**BEFORE THE
FEDERAL AVIATION ADMINISTRATION
U.S. DEPARTMENT OF TRANSPORTATION
WASHINGTON, D.C.**

_____)
)
In the matter of:)
)
Notice of Proposed Rulemaking)
The New York North Shore) **Docket No. FAA-2010-0302**
Helicopter Route)
)
_____)

Comments of the Eastern Region Helicopter Council

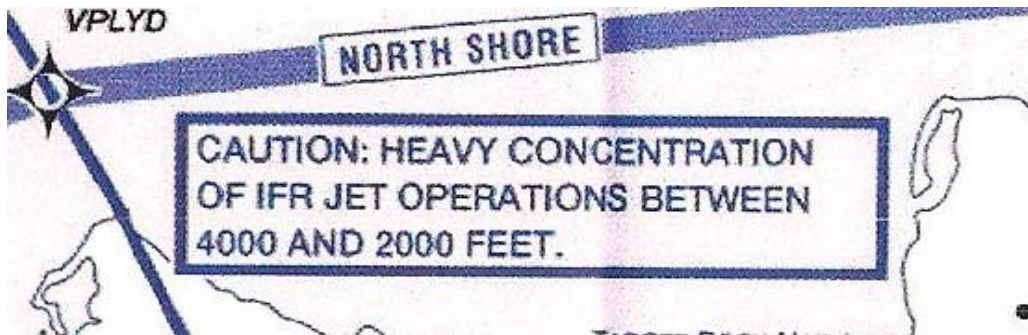
Fifth, the NPRM inappropriately, and potentially unsafely, mixes VFR and IFR operations by concentrating uncontrolled traffic at an altitude and in a location already rife with commercial jet traffic flying into the major airports in the region. The current chart for the voluntary NSHR contains the following warning to helicopter pilots of heavy aircraft traffic between 2,000 and 4,000 feet (and adjacent to the initial GPS waypoint for the NSHR):

Making the NSHR mandatory without controlled airspace with active ATC for separation would result in mixing ATC-controlled IFR traffic with non-controlled VFR traffic, which raises significant operational and safety concerns. Making the NSHR mandatory for VFR operations based on unquantified noise complaints alone, with no regard for the significant safety concerns at stake, would be imprudent and unjustified.
